To: Interested Parties
From: City of Beaverton Planning Division
Date: May 29, 2019
Subject: *Notice of Decision for TP2019-0003 West Point Single Family Home*

NOTICE OF DECISION

PROPOSAL: **West Point Single Family Dwelling Tree Plan
TP2019-0003**

LOCATION: 2895 SW West Point Avenue
Map 1S112BD Tax Lot 2718

Reasonable Alternative No. 1 Site Layout

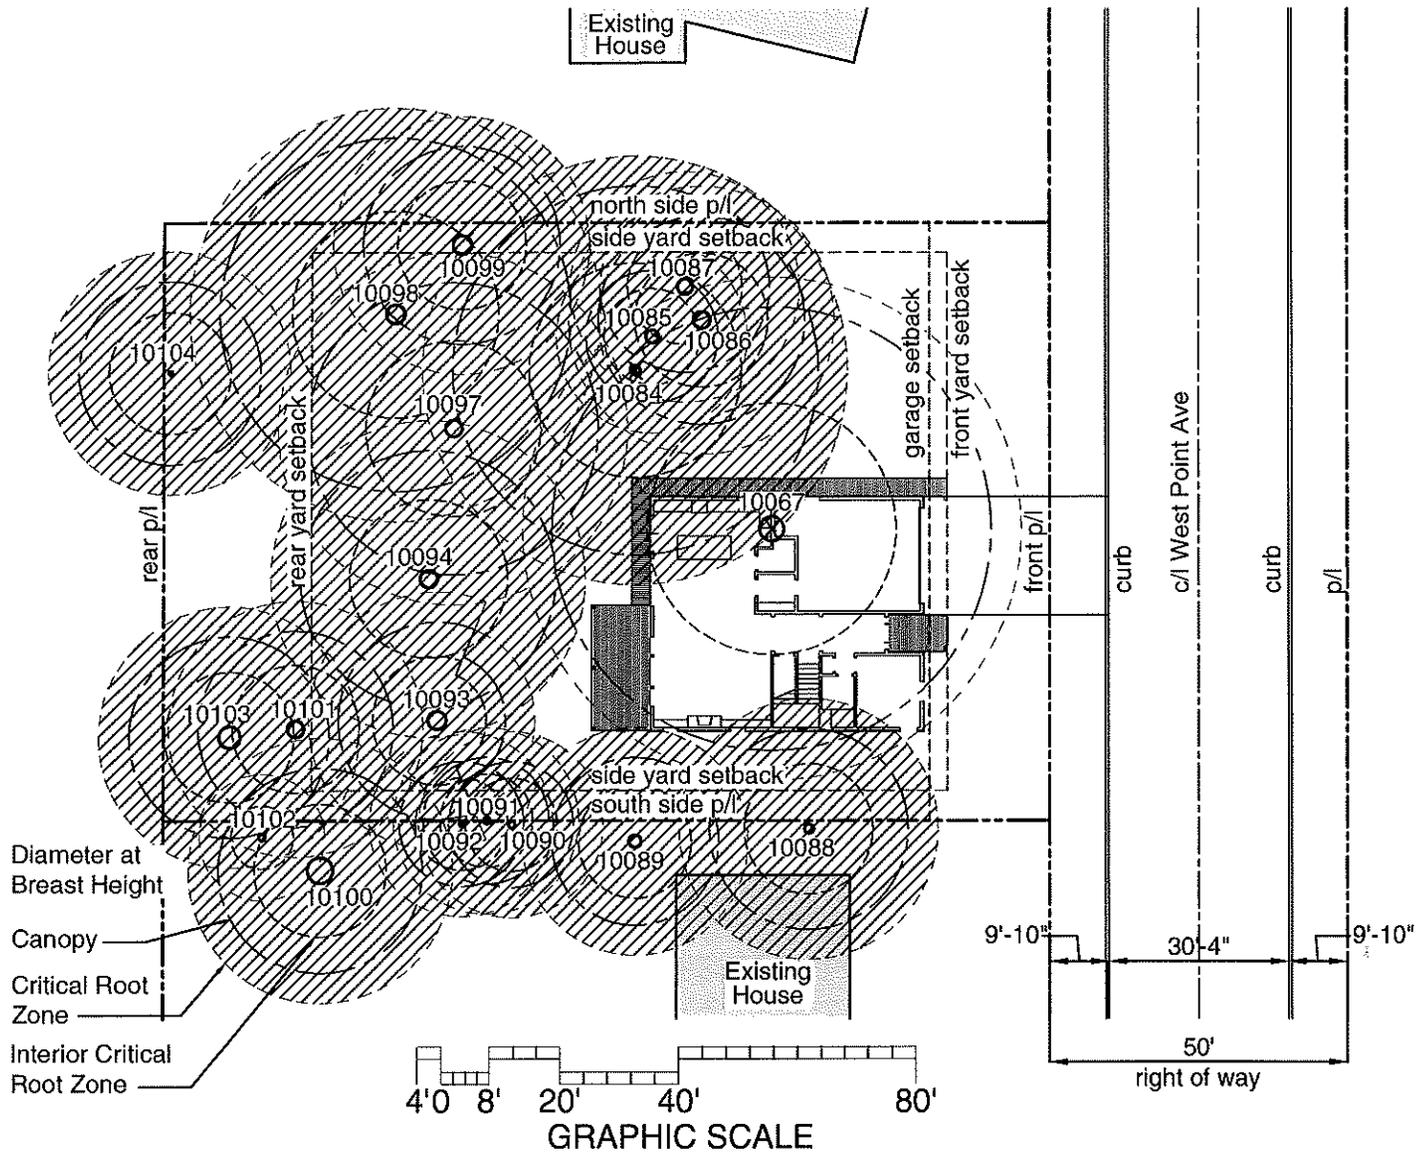
- Sundeleaf Farmhouse Plan by Renaissance Homes with 1 Garage Bay Removed
- 2 protected trees (10084, 10067) fit the criteria for removal unless a reasonable alternative exists
- Significant Douglas-fir tree (10067) in middle of property cannot be preserved
- Will create 2,956 square feet of impervious surfaces from the roof and impervious driveway surfaces. All other walkways to be pervious.
- If the driveway is made pervious, it will reduce the total impervious surface to 2,461 square feet.
- Floor area of ground floor = 1,503 square feet (not including garage area)

Reasonable Alternative No. 2 Site Layout

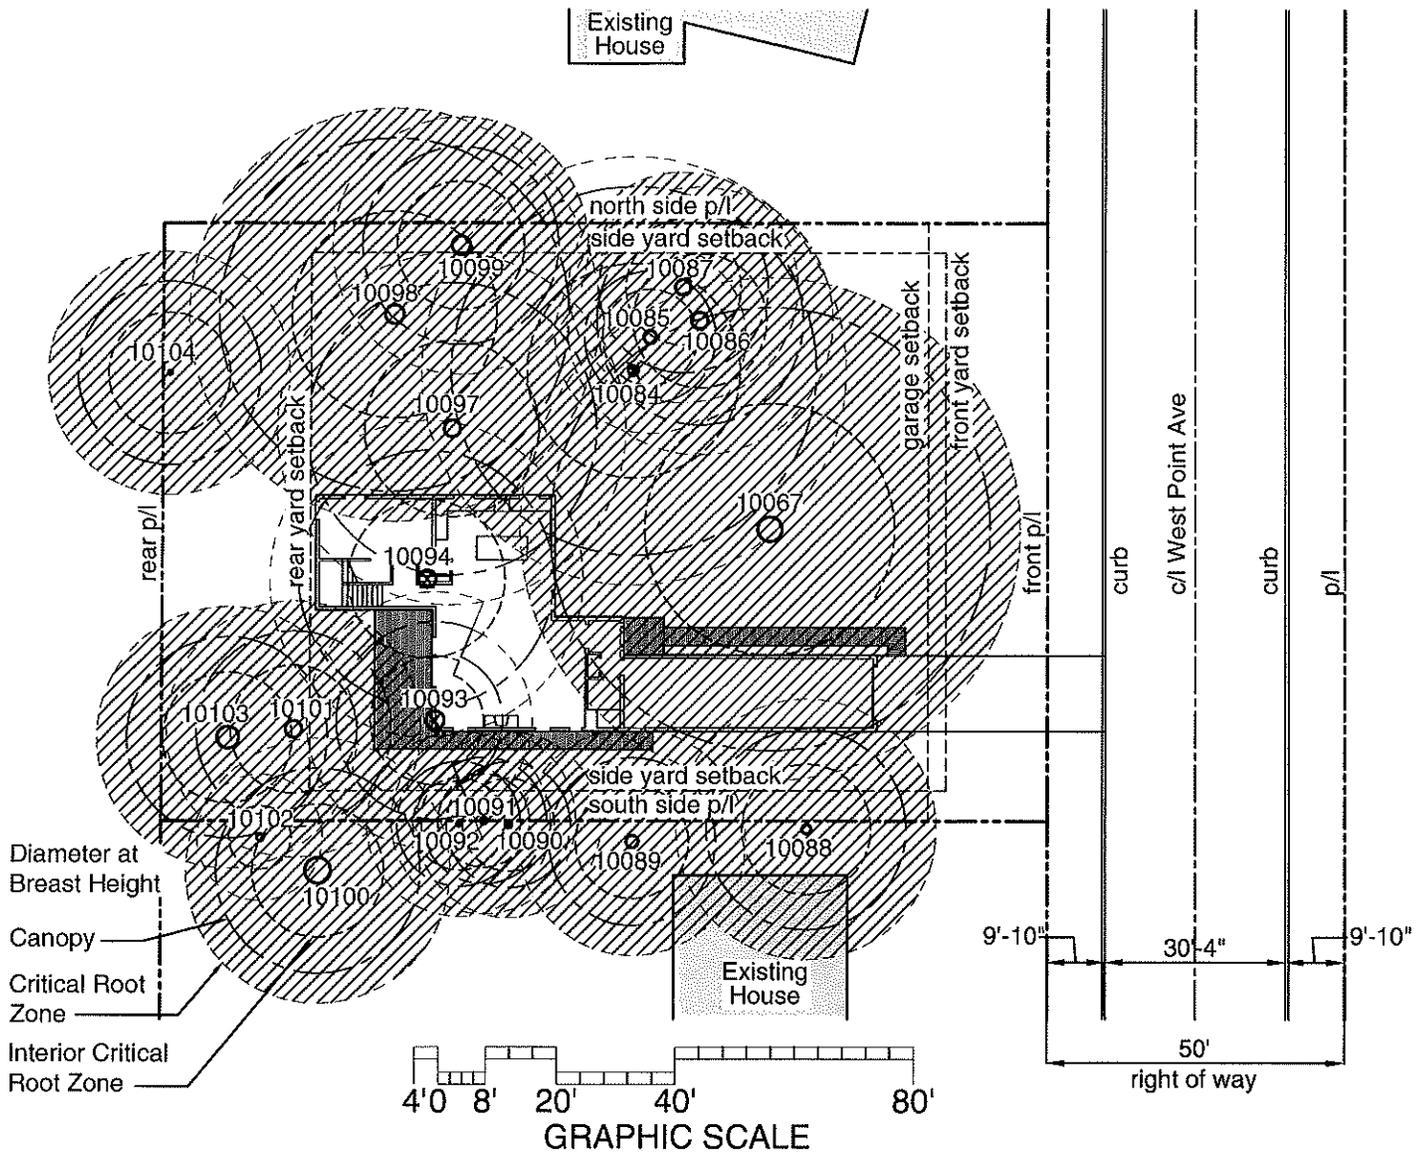
- Thurman Farmhouse Plan by Renaissance Homes with the Kitchen-Great Room reversed
- 1 protected tree (10067) fits the criteria for removal unless a reasonable alternative exists
- Significant Douglas-fir tree (10067) in middle of property cannot be preserved
- Will create 2,385 square feet of impervious surfaces from the roof and impervious driveway surfaces. All other walkways to be pervious.
- If the driveway is made pervious, it will reduce the total impervious surface to 1,972 square feet.
- Floor area of ground floor = 1,323 square feet (not including garage area)

FRONT ELEVATION - EXISTING GRADE REVIEW

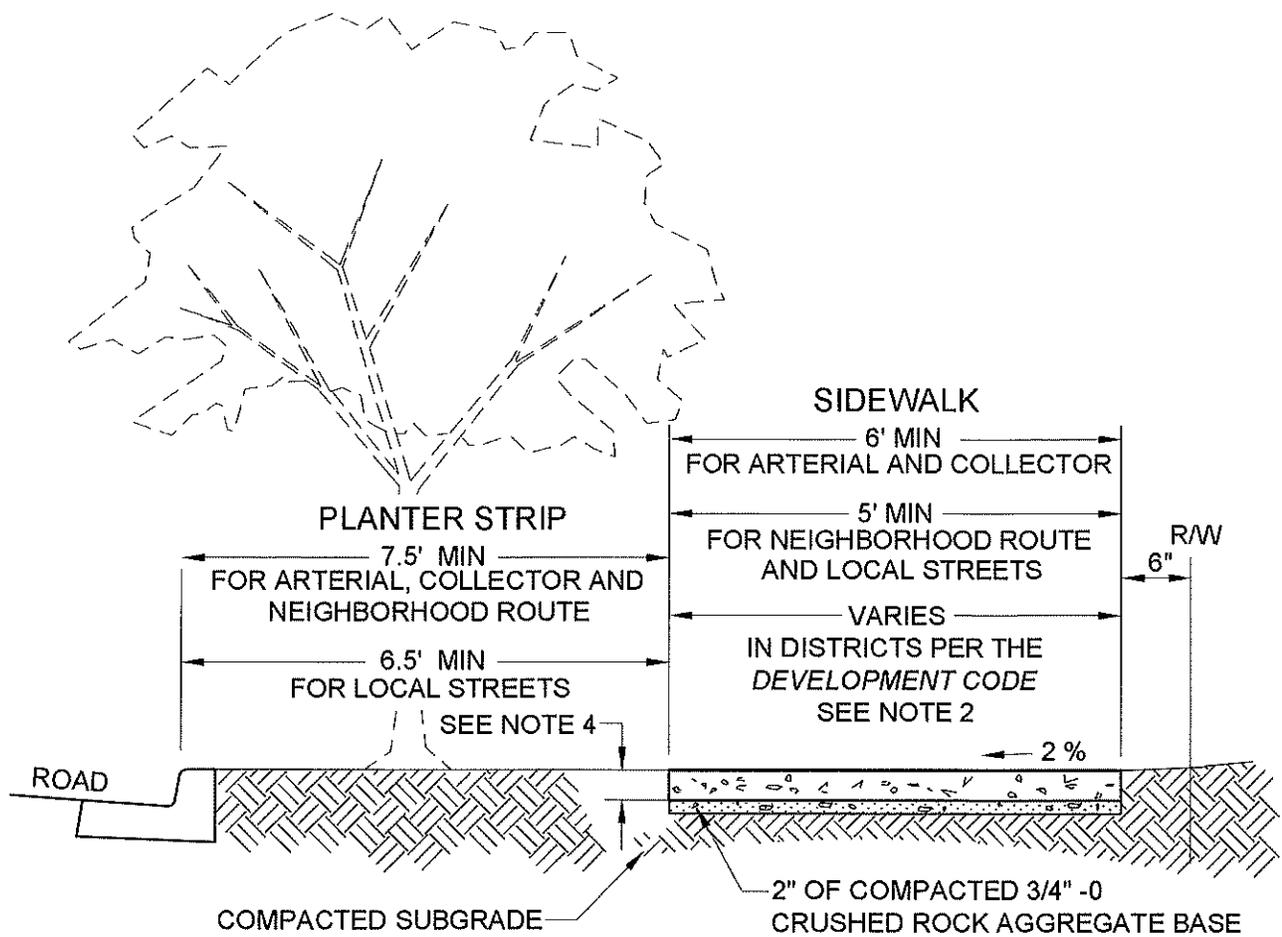
The rendered elevation shows the house setting on a level, flat lot but this will not be the case as there is a significant drop in grade over the width of the lot. I would be interested seeing how they plan to deal with the grade and integrate the structure as it steps down the hill. Along with the slope, I am concerned about additional water runoff from the result of so many trees being removed and how this would affect our friends down the street, as it did when the lots adjacent to this one, were developed. I would like to see the grading plan and how they will address and mitigate the extra runoff from the removal of trees, root systems and reduction of permeable surfaces.
